HISTORIC AND DESIGN REVIEW COMMISSION

HDRC CASE NO: 2025-129
ADDRESS: 118 PARKVIEW DR
LEGAL DESCRIPTION: NCB 6919 BLK LOT 15 & W 12.5 FT OF 16
ZONING: R-5, H
CITY COUNCIL DIST.: 3
DISTRICT: Mission Historic District
APPLICANT: Analiza Alvarado
OWNER: Analiza Alvarado/ALVARADO ANALIZA
TYPE OF WORK: Construction of a 2-story, single-family residential structure
APPLICATION RECEIVED: May 15, 2025
60-DAY REVIEW: July 14, 2025
CASE MANAGER: Edward Hall

REQUEST:

Final Review: Response to Staff Stipulations

03 northwest (front) elevation
SCALE 1/4" = 1'-0"

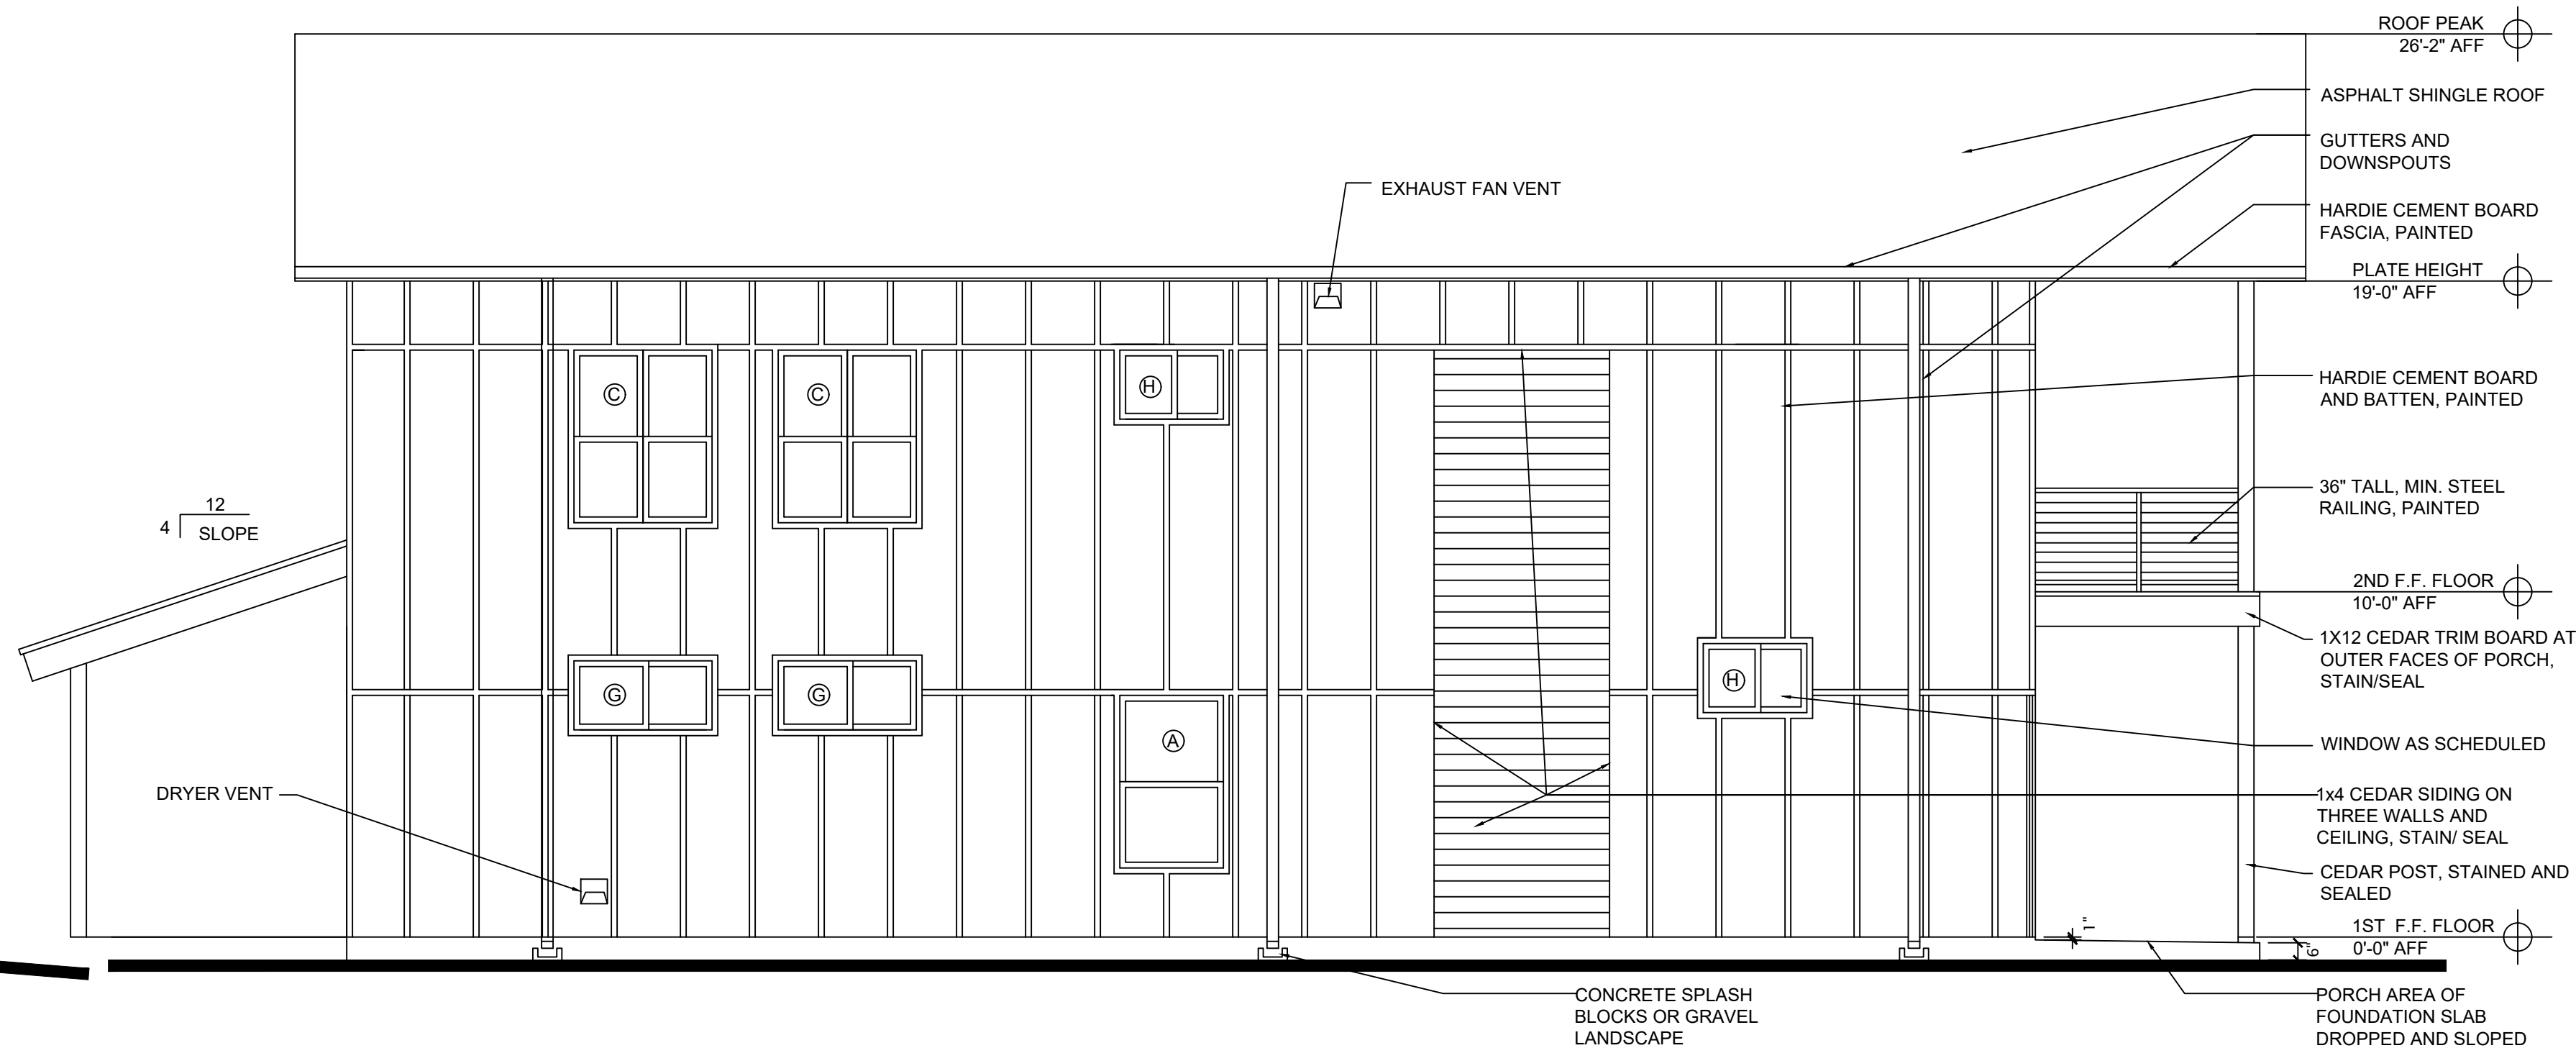
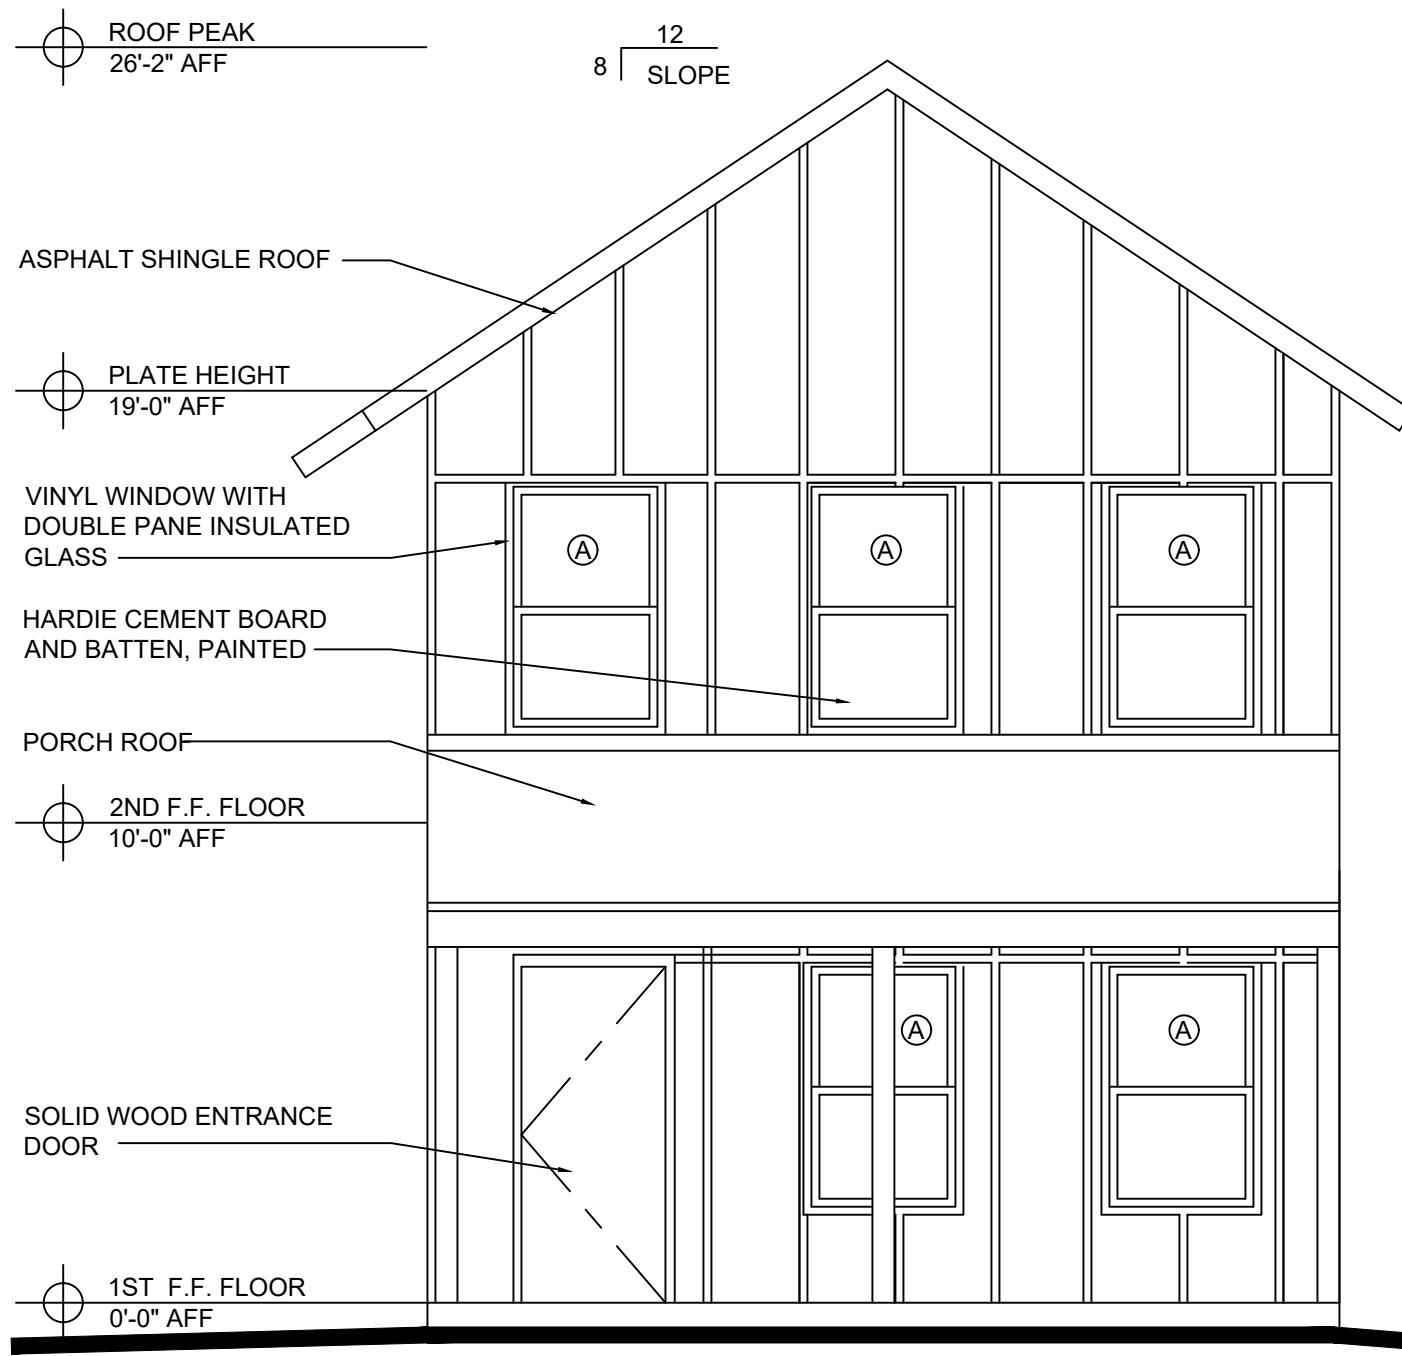
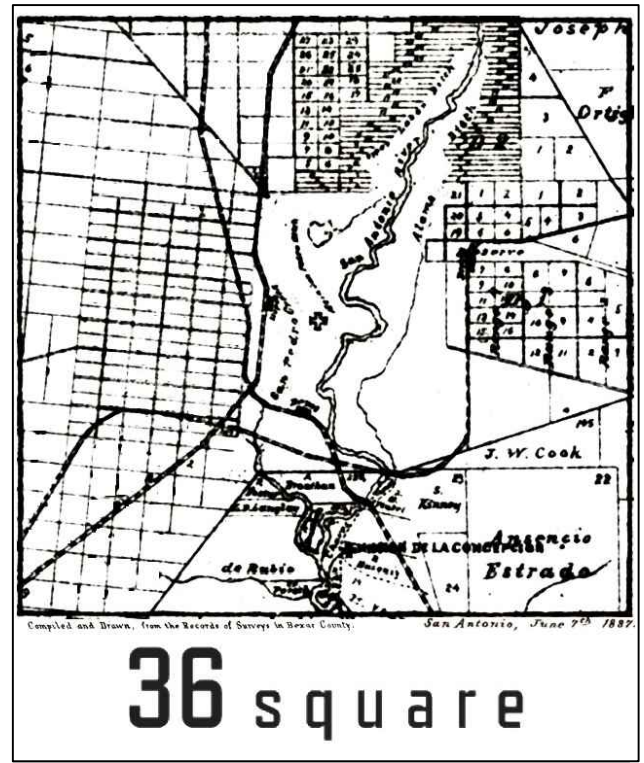
- iii. That a foundation height of approximately one (1) foot should be incorporated. ***This stipulation has been partially met.***
 - iv. That the pitch of the shed porch roof be reduced to relate to those found historically on the block and within the Mission Historic District. ***This stipulation has been met.***

- vii. That all rectangular and square fixed windows be modified in size to accommodate a sashed window and that the three grouped windows at the second level on the west elevation be separated by a mullion of six (6) inches in width, as found historically within the district. ***This stipulation has not been met.***

- h. **ROOF FORM** – The applicant has proposed for the new construction to feature a front and rear facing gabled roof, with a shed porch roof. Historic structures on Parkview and throughout the Mission Historic District feature front and rear facing gabled roofs with simplified shed porch roofs. Generally, staff finds the proposed roof forms to be appropriate and consistent with the Guidelines; however, to reduce perceived massing, a hipped roof should be incorporated into the front, primary roof form.

- l. FENESTRATION PROFILE – Generally, the applicant has proposed window sizes and placement that is representative of those found historically within the Mission Historic District. Staff finds that all rectangular and square fixed windows should be modified in size to accommodate a one over one sashed window. Grouped windows should feature a separating mullion of approximately six (6) inches in width.

- m. PORCH DESIGN – As noted in finding h, staff finds that the pitch of the shed porch roof should be reduced to relate to those found historically on the block and within the Mission Historic District.

4. Porch Roof Pitch

Response: The pitch of the front porch roof has been reduced to 4:12 to reflect historic character. See Sheet A4 (Front Elevation).

7. Window Adjustments

Response: Fixed windows have been replaced with sashed windows, and grouped second-story west elevation windows have been separated by 6" mullions. See Sheets A4 (West Elevation) and A8 (Window Schedule).

01 WINDOW AND DOOR ELEVATIONS

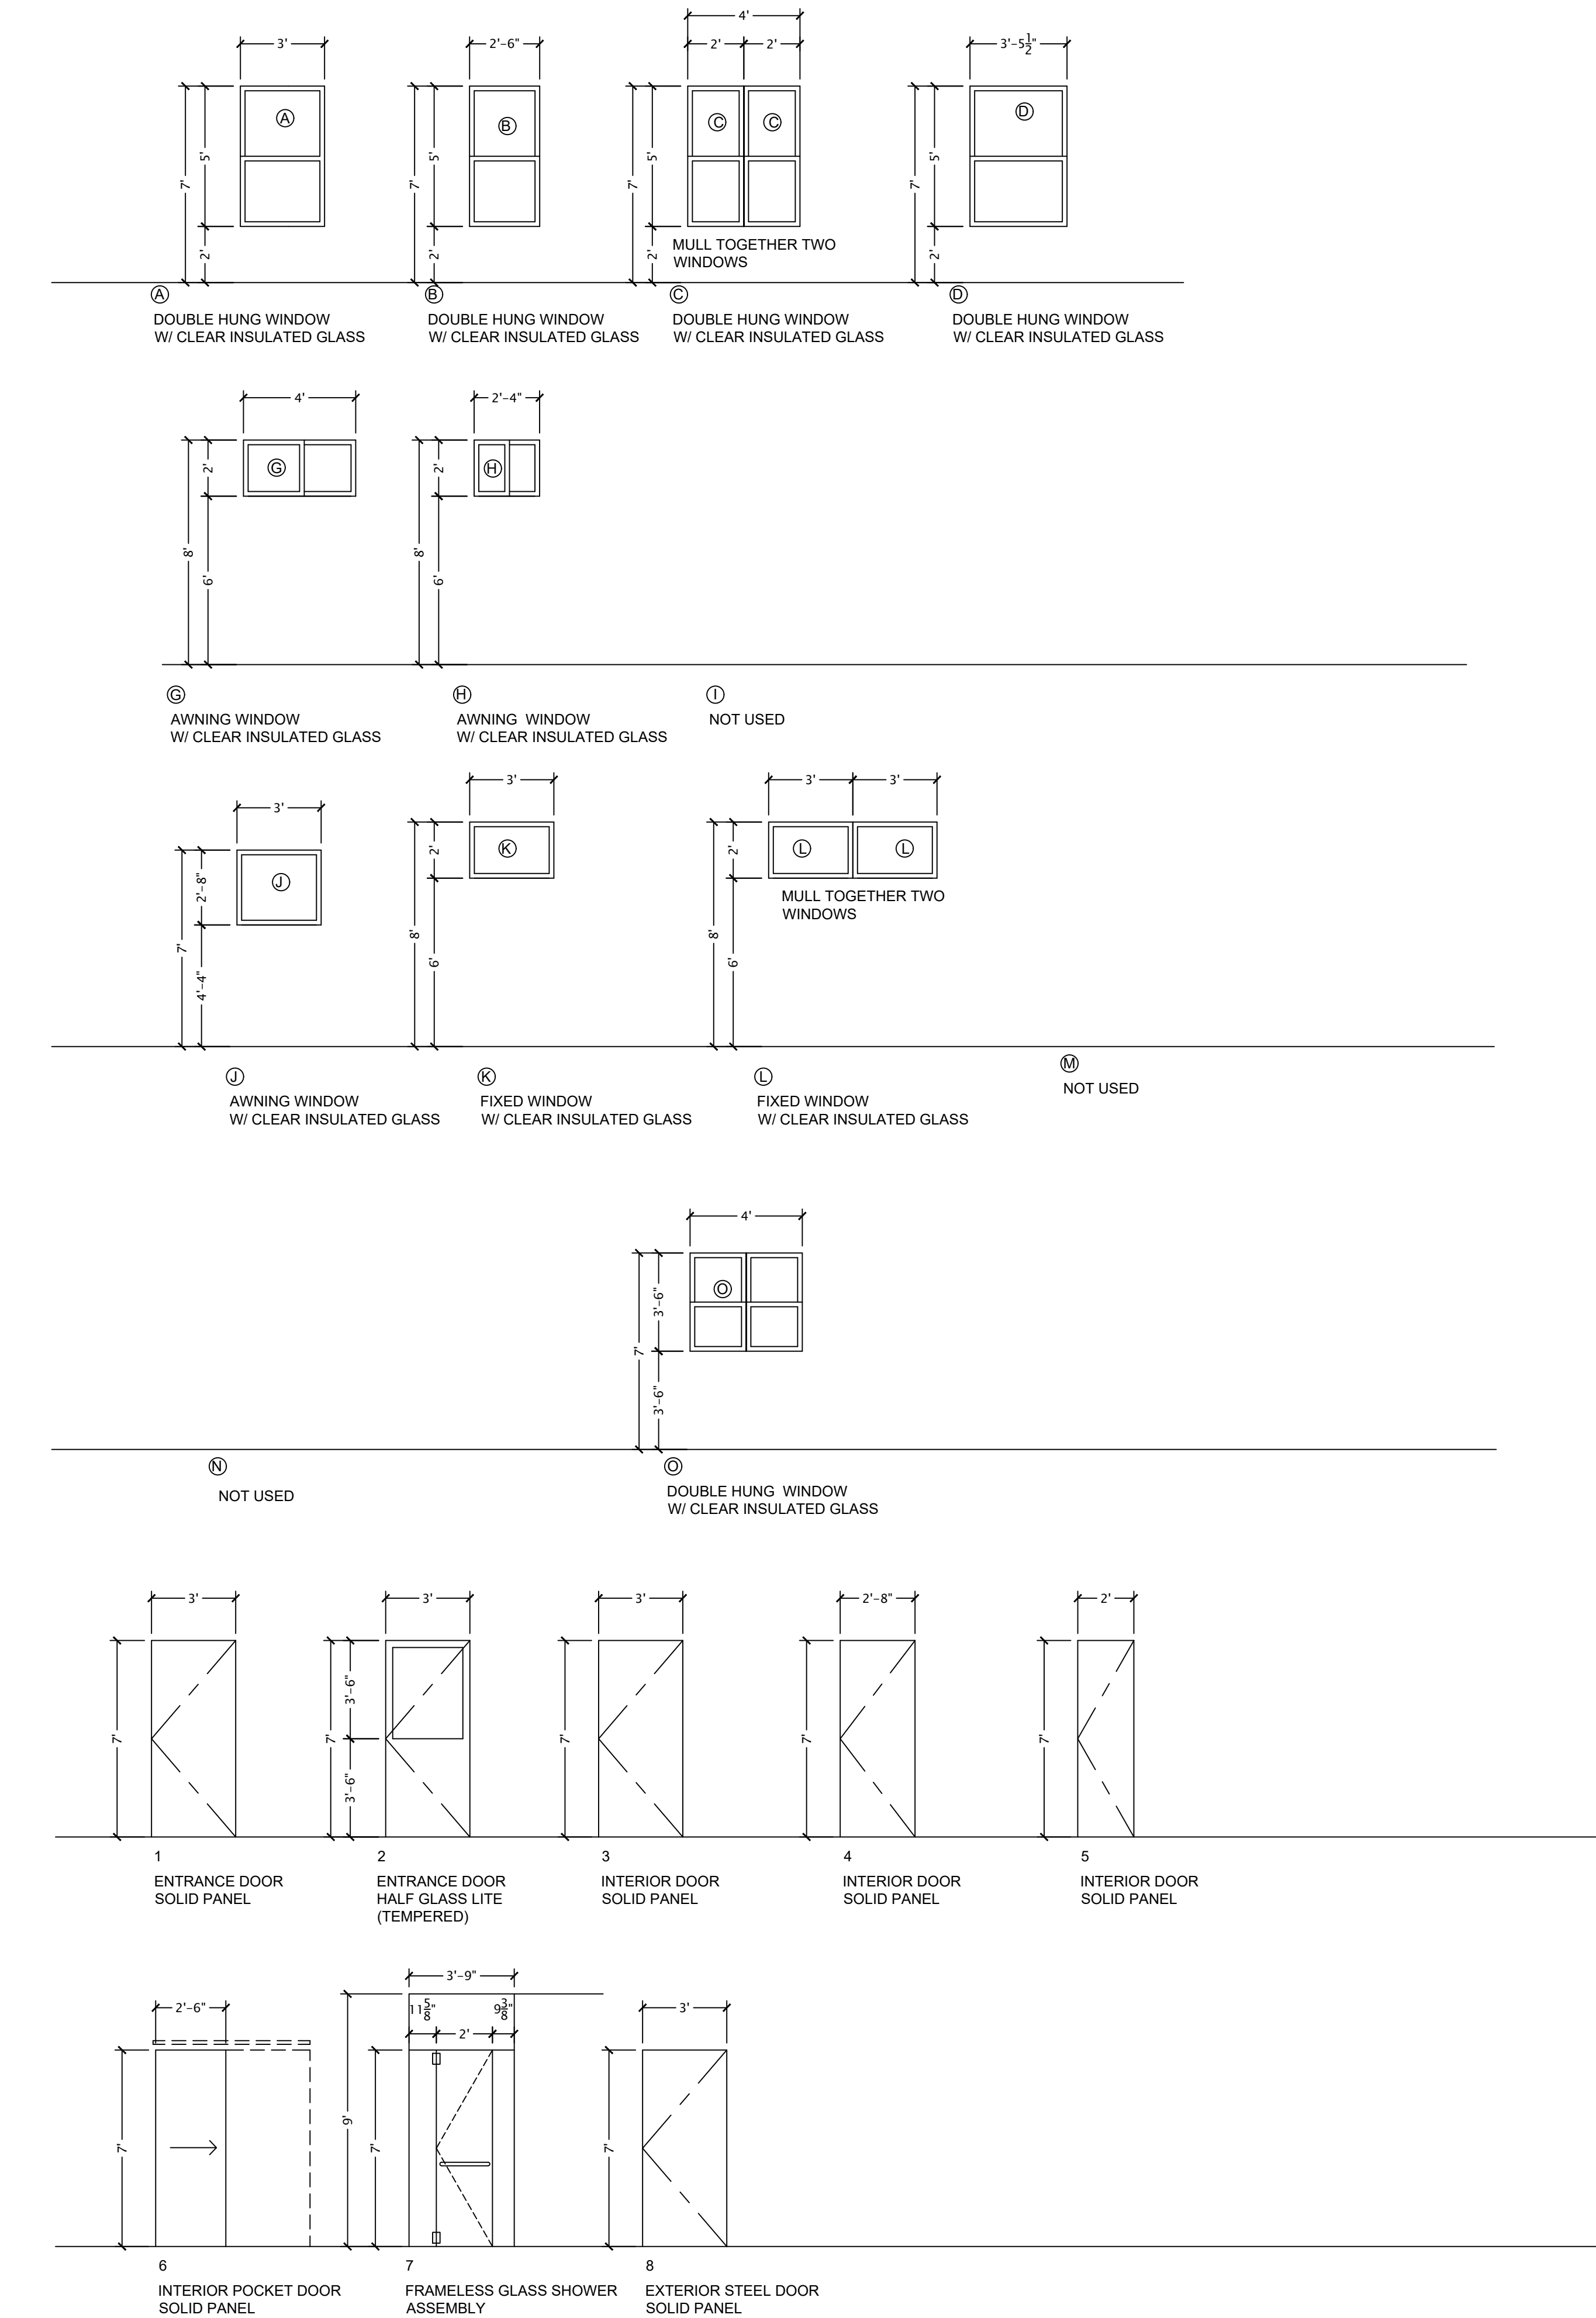
- k. WINDOW MATERIALS – The applicant has proposed vinyl windows; however, window product documents have not been provided to staff for review and approval. Windows should adhere to staff's standards for windows in new construction; no window product or material is prohibited; however, staff finds that a wood or aluminum clad wood window would most consistently adhere to the standards for windows in new construction.

- iv. That grouped windows feature a separating wood mullion of approximately six (6) inches in width.

6. Materials and Windows Compliance

Response: Exterior siding is Hardie board and batten; windows are vinyl double-hung and comply with U-factor and SHGC standards. See Sheets A4 (Elevations), A7 (Wall Sections), and A8 (Window Details).
